KEYSTONE ELECTRONICS CORP.			
www.keyelco.com • NEW HYDE PARK, NY 11040 • Tel (516) 328-7500			
PART NAME			
SNAP RIVET			
MATERIAL			
NYLON 6/6 UL 94V-2 (BLACK COLOR)			
FINISH		DRN BY	DATE
NONE		BOONE	9.29.06
		APP'D	SCALE
		RH	3X
TOLERANCES	INCH	[MM]	CODE
DECIMAL	$\pm .010$	[± 0.25]	UNLESS OTHERWISE SPECIFIED
ANGULAR	$\pm 1^\circ$		
REV.	C		
DATE	DESCRIPTION		
8.27.21	CHANGE AS PER ECN 21-099		
	3447

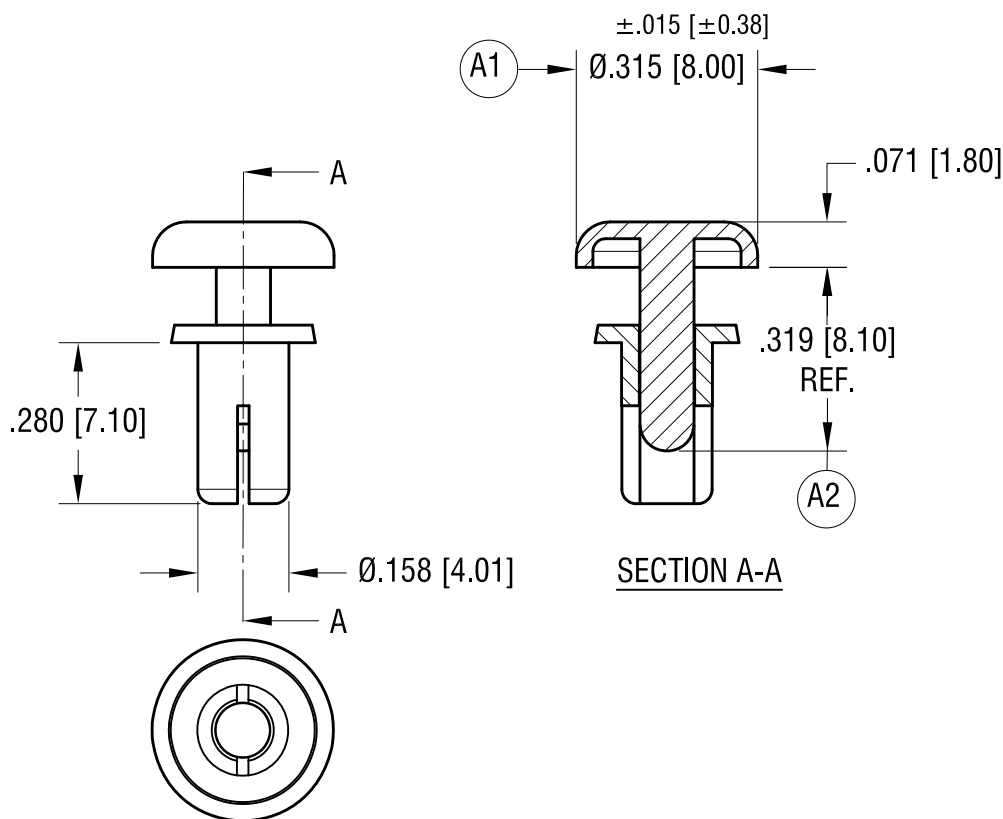
8.27.21 (A1) WAS .315 \pm .010, (A2) WAS .319 \pm .010
CHANGE AS PER ECN 21-099
